# CONN HOUSE

## S4.55 MODIFICATION ISSUE A

**DRAGONFLY  
ARCHITECTS**  
PTY LTD

**SITE PLAN/WASTE  
MANAGEMENT PLAN, SITE  
ANALYSIS AND LOCATION  
MAP**  
DFA1905-A03

1 SITE PLAN/WASTE MANAGEMENT PLAN  
Scale 1:500

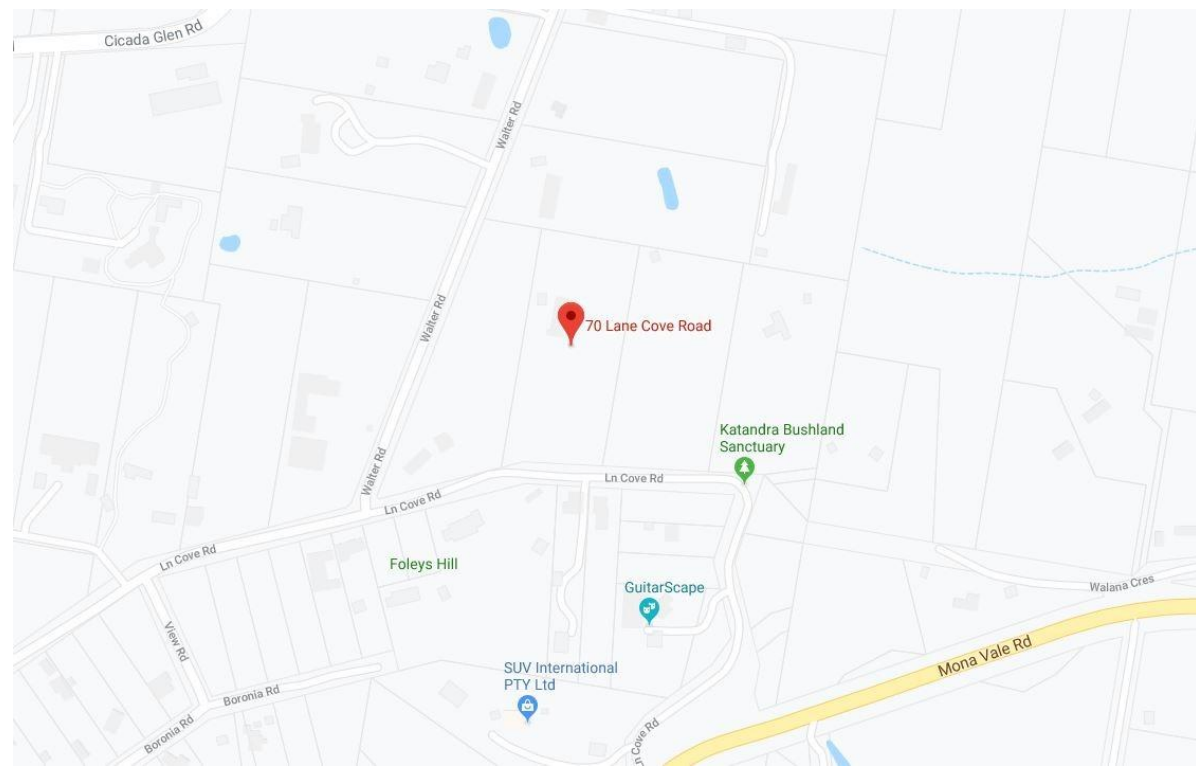
TEMPORARY HAY BALES  
OR SIMILAR SEDIMENT  
CONTROL, AS REQUIRED.  
GLASS POOL FENCE  
AND GATE TO NCC  
& ALIST  
STANDARDS.  
RECONFIGURED  
PAVING & POOL  
LAYOUT.  
REMOVE DA APPROVED  
SKYLIGHTS  
KEEP AND PROTECT  
EXISTING STRUCTURE  
DASHED LINE OF DA  
APPROVED  
ADDITION TO BE  
REMOVED.  
OUTLINE OF EXTERNAL  
WALLS BELOW ROOFS.
